### CBJ Water Reservoir 2010 Corrosion Repairs & Valve Vault Painting

Contract No. E10-217

**ADDENDUM NO.:** ONE

**SECTION**

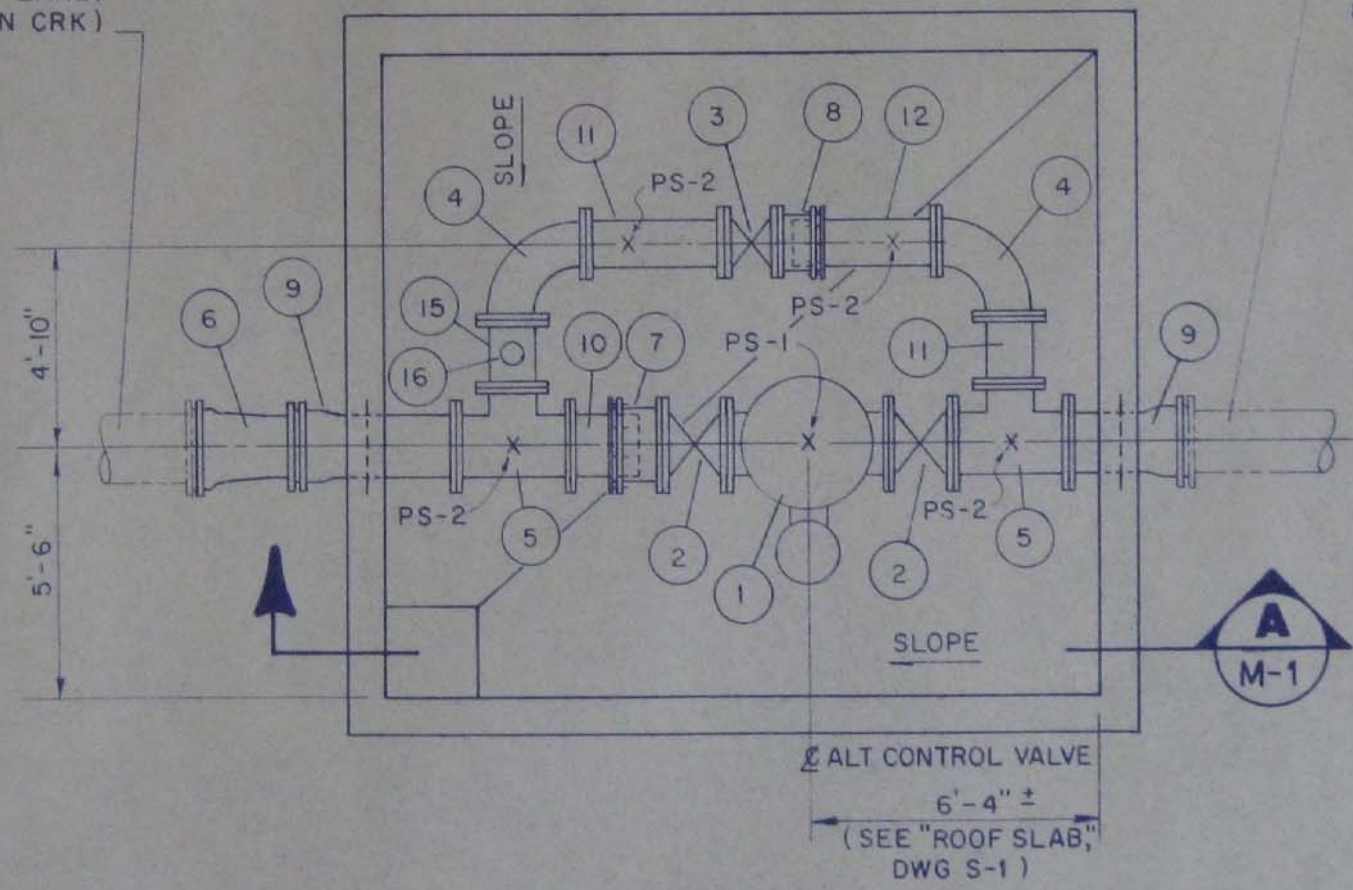
Item No. 1 Included is additional Information on what needs to be painted in the vaults at the Lemon Creek and Auke Lake Reservoirs shown in the attachments from the as-built drawings of the Sheet M-1 Control Valve Piping, Juneau Areawide Water System, 1984 Improvements: Auke Lake and Lemon Creek Reservoirs, By Quadra Engineering,

1. Piping Material List
2. SECTION A
3. Piping Plan
